Re: Gateway Retail – Development Plan Application
London-Groveport Road (S.R. 665) & Meadow Pond Court
Grove City, Ohio

Following is the disposition to first review comments (dated 8/22/2016) for the referenced project:

1 PLAN VIEW
 X Not To Scale 2010 Trash Icon

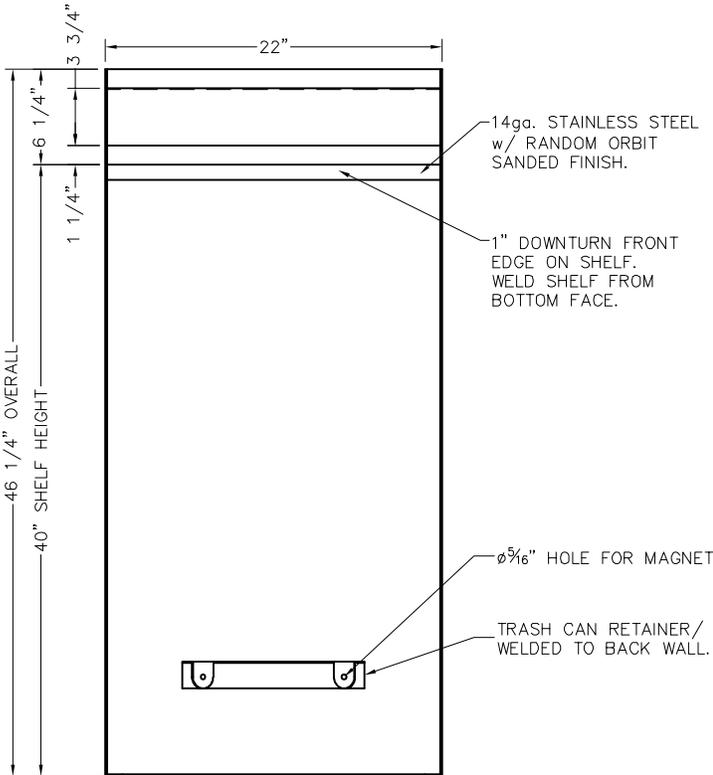
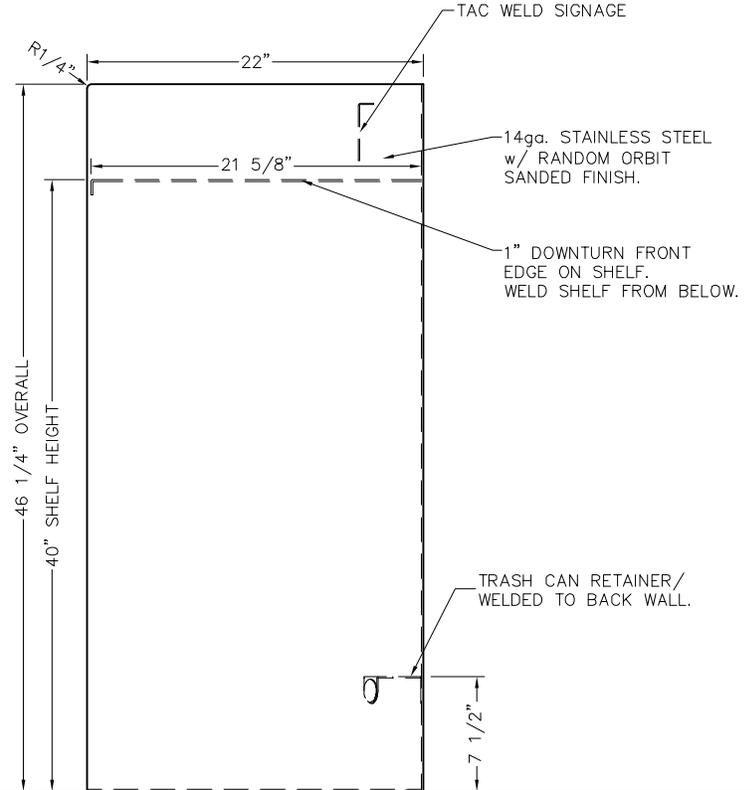
2. Details for any site furnishings and fixtures should be submitted, including bollards, benches, and trash receptacles. Furnishings should be black, decorative metal.

Response: The tenants are still considering options and the details will be worked out as the project progresses. Possible options under consideration are included in this submittal.
